SYDNEY NORTH PLANNING PANEL SUPPLEMENTARY ASSESSMENT REPORT

Panel Reference	2015SYW189
DA Number	DA0418/15
LGA	Ku-ring-gai
Proposed Development	Demolish structures (except dwelling at 25 Bushlands Avenue) and construct a residential care facility, basement parking and landscaping works under the provisions of SEPP (Housing for Seniors or People with a Disability) 2004.
Street Address	25, 25A and 27 Bushlands Avenue, Gordon
Applicant	Australian Nursing Home Foundation C/O Mark Boffa
Owner	Ms Mei Mei Tse, Mr Bernard Tse, Ms Monica Chu, Mr Andrew Gock, Ms Ellen Louie
Number of Submissions	Original DA: 108 submissions and a petition with 11 signatures objecting to the proposal. 227 submissions (predominantly form letters) and a petition with 8,803 signatures in support of the proposal. Amended DA: 64 submissions objecting to the proposal and 1 submission in support Amended DA in response to SNPP deferral: 32 submissions
Regional Development Criteria (Schedule 4A of the Act)	'General development over \$20 million'

consideration	ARUP Attachment D – TAG Review of the ARUP Acoustic Review Attachment E – ARUP response to the TAG Review Attachment F – TAG response to the ARUP response Atta

Figure 1 - extract from original west elevation

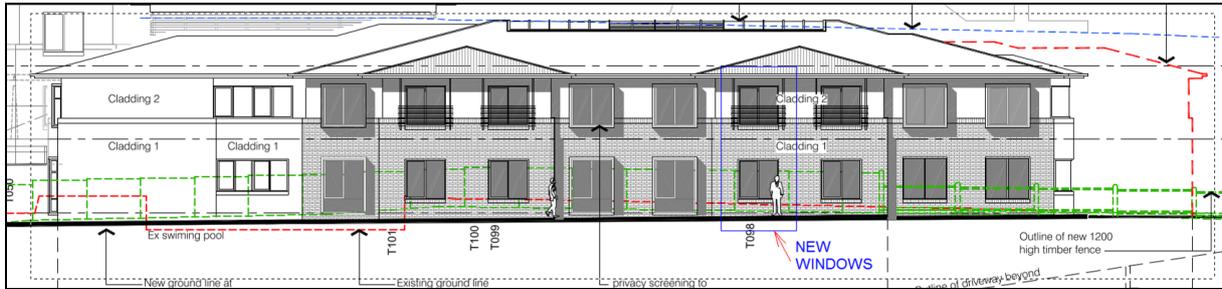
1. The western building should be set back to the predominant alignment of the existing heritage dwelling on the site.

The street setback of the western building has been increased by 5.31m, from 14.6m to 19.91m. The street setback of the heritage item No. 25 Bushlands Avenue is 19.2m.

The number of beds in the West Wing has been reduced by four. One window (with a privacy screen) has been added to the western elevation at the first floor level and one window has been added to the western elevation at the ground floor level. The projecting bay at the northern end of the elevation has been moved 3m north. There is no change to the minimum side setback of 3.5m.

Figure 3 - the red shading represents the 25m² increase to the area of the courtyard

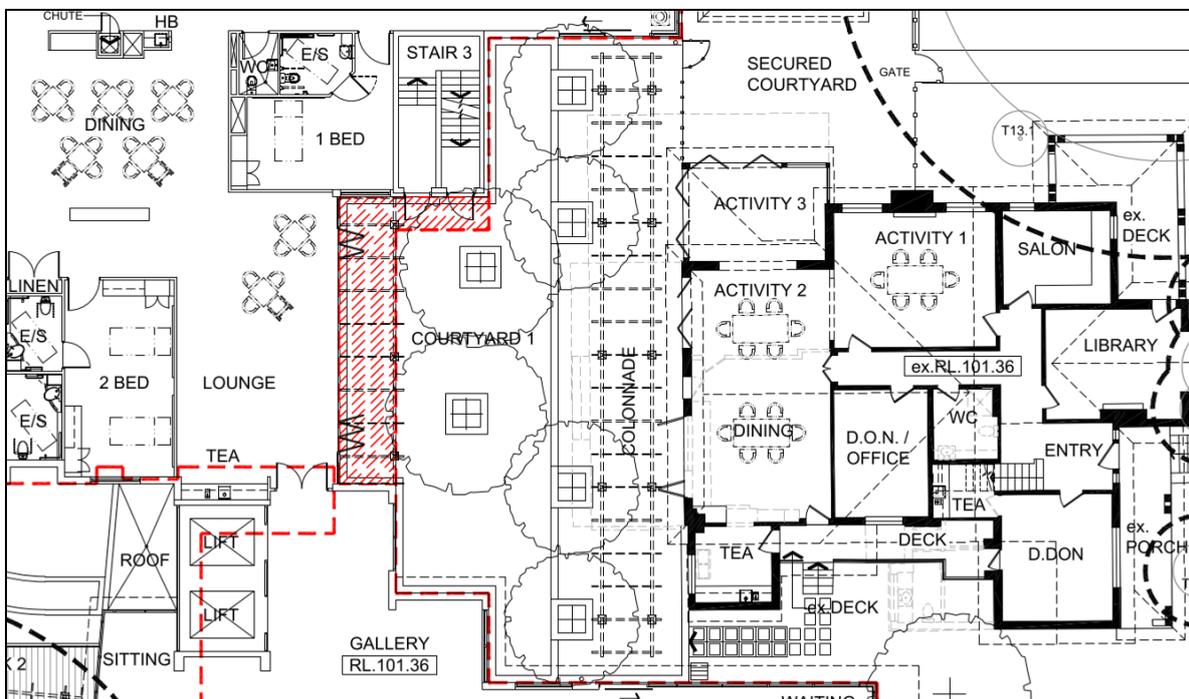
2. Courtyard 1 at the rear of the existing heritage item should be increased in size and allow deep soil to allow the growth of large, centrally located (15m plus) trees to maintain the backdrop to the heritage item. This may require the design of the basements to be amended.

Courtyard 1 has been widened by 2m to a total of 11.7m in a north-south direction by reducing the depth of the lounge room and by 1.3m in an east-west direction by moving Stair 3. A glass roof pergola has been added to the northern side of the courtyard in the area previously occupied by the lounge room and the stairs. The area of the courtyard has been increased by 25m², however 21m² of the additional area is covered by the pergola.

Figure 4 – the green shading represents the increased setback from the rear wall of the heritage item

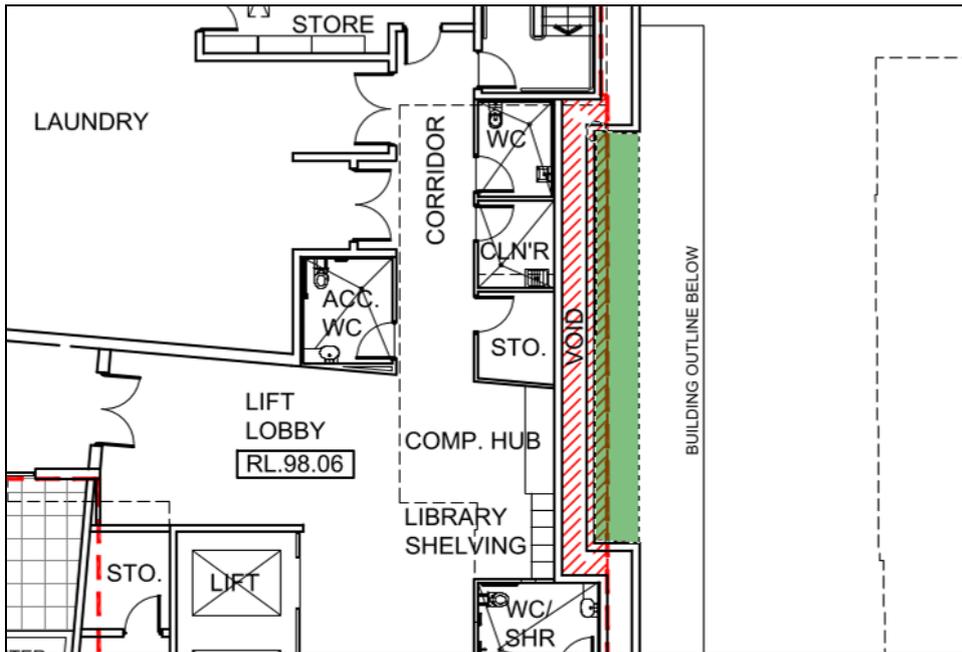
At the basement level below the courtyard, the external wall has been moved 1m further back from the rear wall of the heritage item.

Figure 5 – extract from amended landscape plan

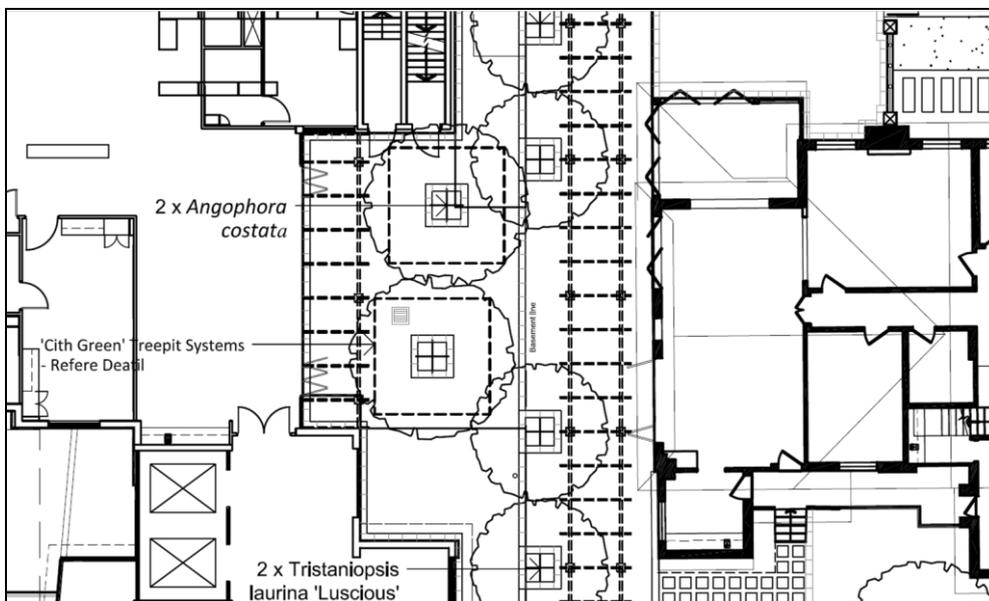
The landscape plan has been amended to include the construction of two tree pits with dimensions of 4m x 4m x 1.8m in the courtyard. Each tree pit is to accommodate an Angophora Costata (Sydney Redgum) with a 75 litres container size at the time of planting. The landscape plan nominates a mature height of 20m and canopy spread of 6m for the selected tree species.

The proposed courtyard at the rear of the heritage residence is considered of inadequate size to support the two proposed canopy trees. The building setbacks (approx. 2.6m and 3.5m) from the rear two storey building are insufficient as the mature spread of the proposed Angophora costata (Sydney Red Gum) is approximately 15-20 metres diameter (6 metres

diameter shown). To ensure long term viability of the proposed trees, a minimum 5 metres setback from buildings is recommended. If the *Tristania* plantings were removed, it would provide space for greater setbacks for two canopy trees of a different species and with a more upright form. Alternatively, one canopy tree at the rear of the heritage dwelling centrally located as a specimen within a slightly larger rectangle of garden would achieve the desired visual outcomes. Similarly, the removal of the *Tristania* would also benefit the viability of a single taller canopy tree.

The Tree Pit Detail is not supported for the following reasons:

- i. The proposed root barrier as part of the tree pit is considered unnecessary on the western side and beneath the planter considering the proximity of concrete basement walls. The proposed dimensions of the root barrier are likely to compromise the long term viability of the proposed tree planting.
- ii. The proposed drainage medium should be associated with the basement slab to achieve minimum soil volumes to support proposed mature tree (refer Control 7(i) Part 23.5, KDCP in regards to soil volumes of large trees on slab).
- iii. Crushed granite is unsuitable for locally occurring vegetation and would be preferable to be substituted with drainage cells.

The above issues can be addressed by **Condition 27** in the without prejudice conditions set.

Figure 6 - west elevation of amended roof form – original roof shown as a red dashed line

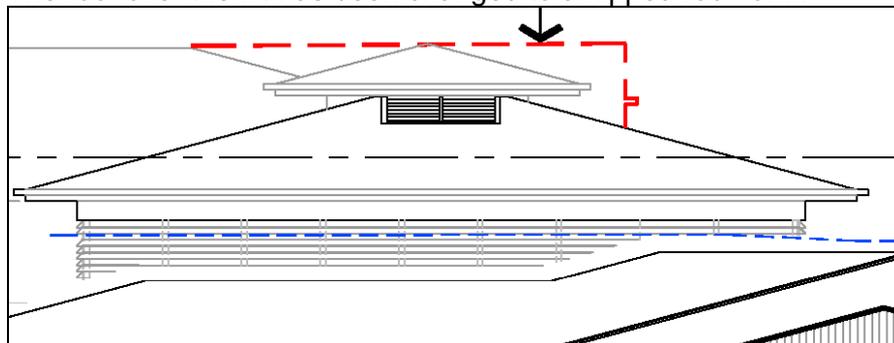
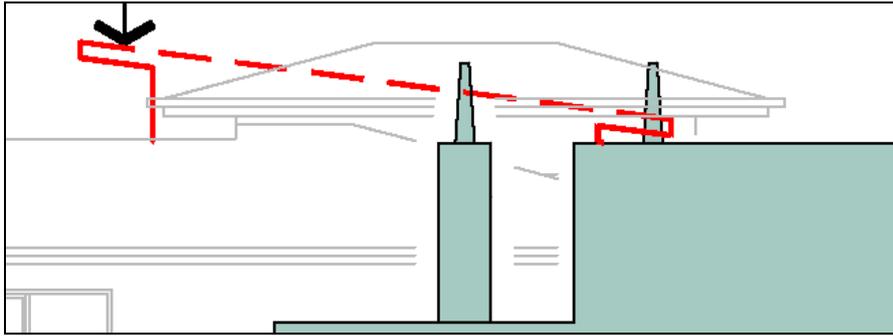
4. The skillion roof over the lift is to be a traditional hip to match the remainder of the development.

The roof over the lift has been changed to a hipped roof form.

Figure 8 - setbacks of the East Wing at the rear boundary

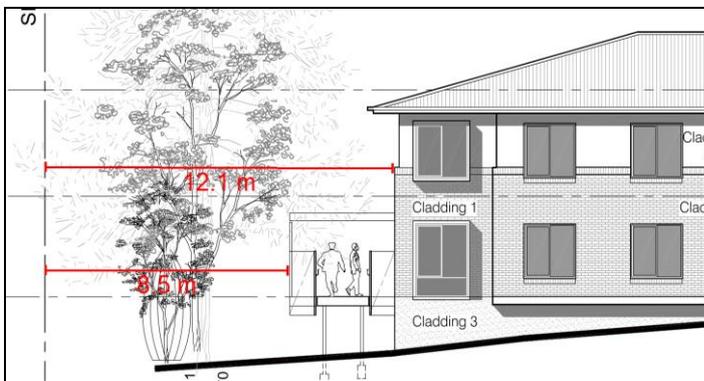
5. The rear setback is to be increased to 12 metres minimum to reduce the adverse impact on the St Johns Avenue Conservation Area.

The rear setback has been increased by 5.56m, to 12.1m and a raised deck has been added. The rear setback is greater than 12m. The number of beds in the East Wing has been increased by four (from 46 to 50) through changes to the internal layout.

Figure 9 - bus exiting

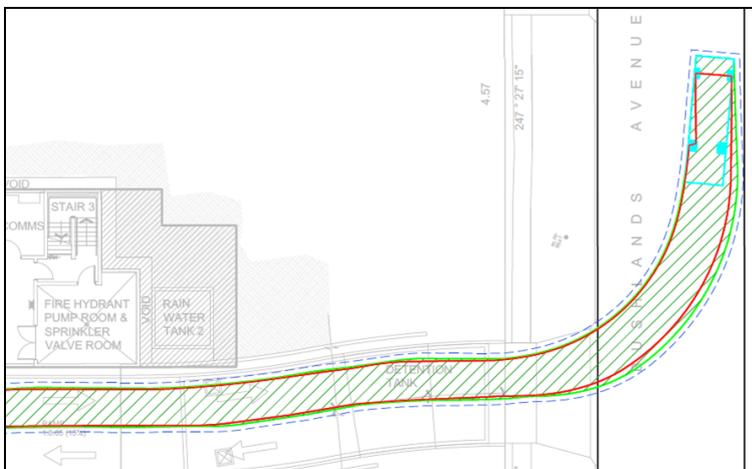
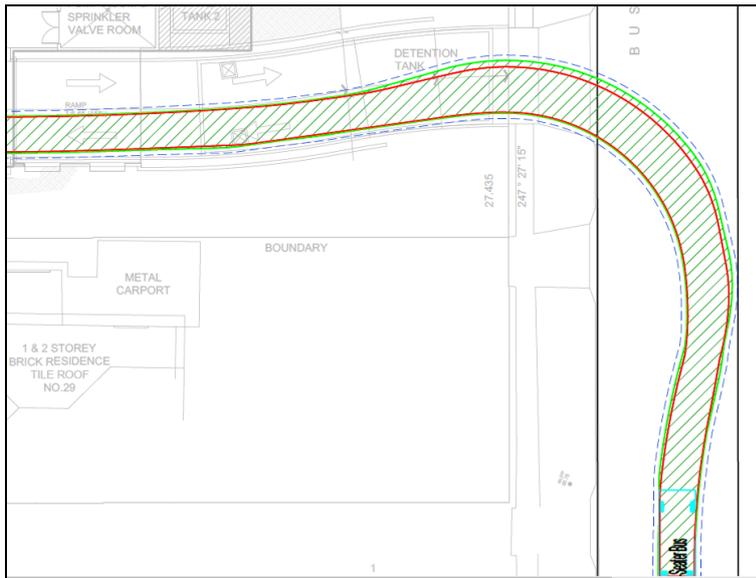
An amended Traffic Report has been submitted. The report includes swept path diagrams for a bus entering and exiting the basement. The swept path diagrams show that the bus will need to cross the centre line of Bushlands Avenue in order to enter or exit the basement.

The traffic report contains turning paths for these vehicles entering and leaving the basement. These manoeuvres can be accommodated within the roadway without encroachment onto the grass verge opposite. Parking of vehicles opposite the site entry is considered to be unlikely to impede access due to the layout of driveways and the low incidence of parking on the verge, however, for abundant caution, a condition is recommended that the applicant approach the traffic committee with a request for parking restrictions prior to occupation of the development. If the traffic committee is minded to approve the request, the length of the restriction can be determined at that time.

Reference is made to AS2890.2:2002 Off-street commercial vehicle facilities. The bus service is defined as a Regular service – Minor road. Section 3.2.4b) of the Standard states “The swept path of the maximum size design vehicle using the facility may be allowed to occupy the entire width (less specified clearances) of a two-way access driveway when the vehicle is entering or leaving the minor road”.

A template of the bus path was shifted over on the plans of the bus swept path entering and exiting (painted median). If the bus uses the entire width of the driveway at the entry it can avoid crossing the centreline of Bushlands Avenue. (Note the Standard also allows reversing onto or off the street if permitted by the relevant authority).

The relatively gentle entry ramp gradient will allow for the bus driver and any driver entering or leaving in the opposite direction to see each other. Keeping in mind that the overall traffic generation will be low.

On the basis of the above it is considered that the proposal will safely accommodate the anticipated vehicle movements.

Figure 11 - Wall height at western elevation. The red dashed line is the existing ground line.

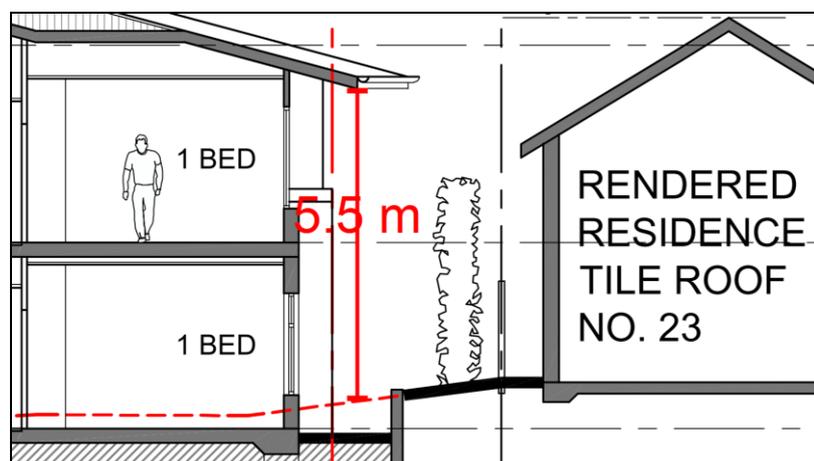
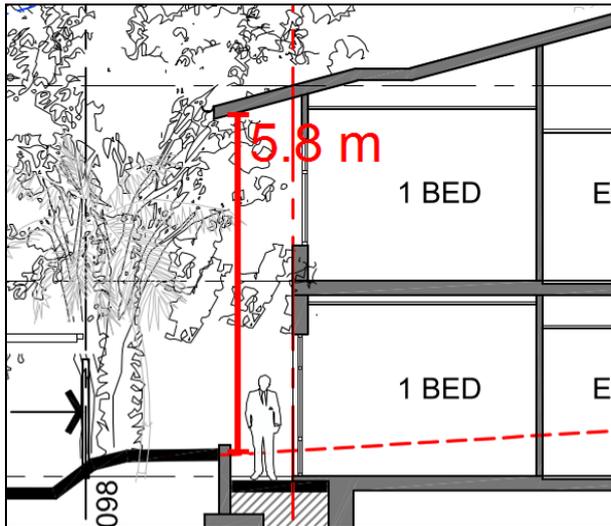
The side setbacks are inadequate, they should be a minimum of 6m

Whilst the length of the side elevations is greater than the streetscape character, appropriate modulation of the built form has been achieved. The height of the side walls has also been minimised by retaining walls adjacent to the side boundaries which allow for finished floor levels that are below the existing ground levels. Despite the two storey height of the building, the retaining walls allow for side walls that have a maximum height of less than 6m.

Figure 13 - windows with green shading should have privacy screens

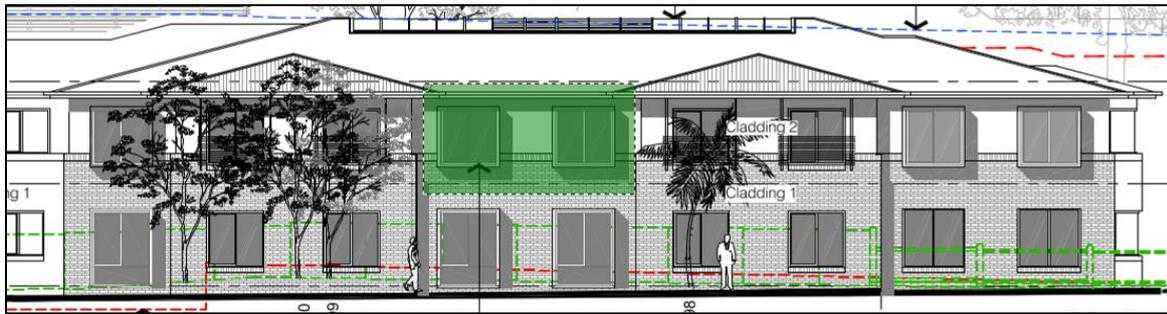
The amended proposal has not addressed overlooking of 29 Bushlands Avenue

The amended plans include two new windows on the western elevation, one at ground floor level and another at first floor level. The window at the first floor level has a privacy screen. The amended plans have deleted the privacy screen from one of the first floor windows. The

windows in the centre of the elevation should have privacy screens as they are opposite the courtyard at the rear of 29 Bushlands Avenue.

Condition 40 in the without prejudice conditions set requires the additional privacy screens mentioned above.
